Canadian Science Advisory Secretariat
Science Response 2016/045

TECHNICAL REVIEW OF ROBERTS BANK TERMINAL 2 ENVIRONMENTAL ASSESSMENT: SECTION 9.5 – COASTAL GEOMORPHOLOGY

Figure 1: TELEMAC-3D model domain (Port Metro Vancouver Environmental Impact Statement, Appendix 9.5-A, Figure 2. Used with permission).

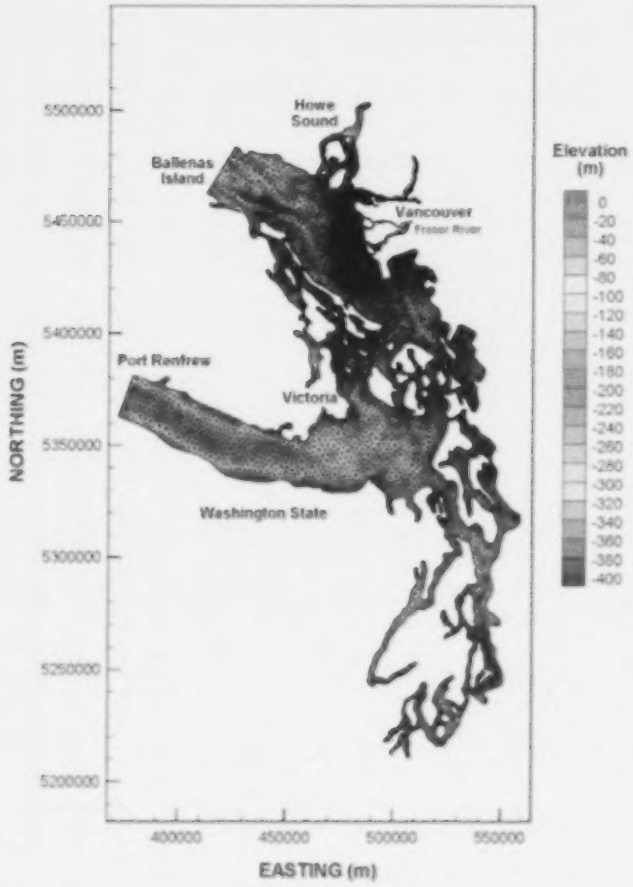
The model grid includes Juan de Fuca Strait (east of Port Renfrew), Puget Sound, the lower Fraser River (up to 36 km upstream of New Westminster), and the Strait of Georgia (south of Ballenas Island) (Fig. 1). The grid has 28000 nodes in the horizontal and 11 vertical levels. The horizontal resolution varies from 3 km in the Strait of Georgia to about 25 m in the vicinity of the project.

The TELEMAC-3D model is forced by the Fraser River flow at the upstream river boundary, and by tidal water levels from the main eight tidal constituents at the Port Renfrew and Ballenas Islands boundaries (see Fig. 1). Tidal levels at the open boundaries were obtained from the
